PRODUCT CHANGE NOTIFICATION

Bourns® Model PM7032S and SRR7032 Series Shielded Power Inductors Change to Inductor Core, Shield and Winding Design

Riverside, California – September 23, 2021 – Effective March 19, 2022, Bourns will change the inductor core, shield and winding design for the [Model PM7032S](#) and [SRR7032 Series Shielded Power Inductors](#) to improve the component's quality and reliability.

Existing Core Design

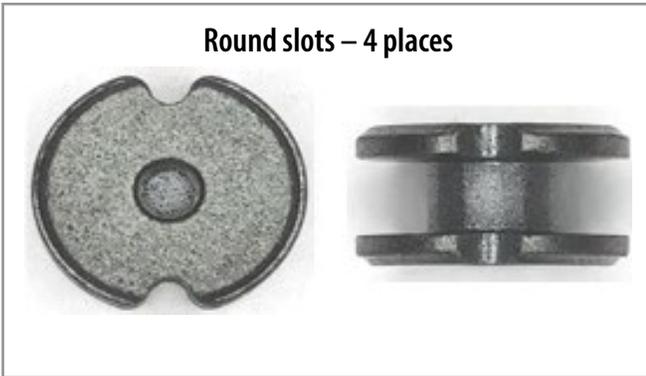
- **All part numbers of PM7032S and SRR7032 series:** There will be a new core design that is constructed without the round slots to increase inductance stability.
- **All part numbers of PM7032S and SRR7032 series:** There will be a new shield design that includes eight protrusion lines along the inside diameter of the shield to facilitate consistent gapping between the core and shield.
- **Select part numbers with inductance values 47 – 1000 μ H of PM7032S and SRR7032 series:** The wire insulation thermal class will be upgraded to 180 °C from 150 °C.
- **Select part numbers with inductance values 2.2 – 33 μ H of PM7032S and SRR7032 series:** The winding will change from multiple wire strands to a single strand in larger wire diameter to increase manufacturing efficiency. The inductor DC Resistance (DCR) specification remains unchanged.

Round slots – 4 places

New Core Design

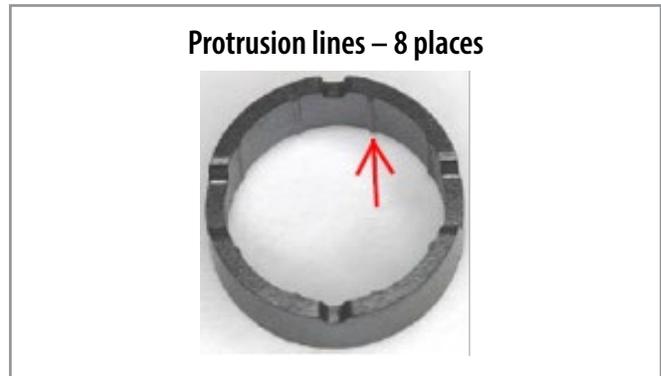
Round slots excluded
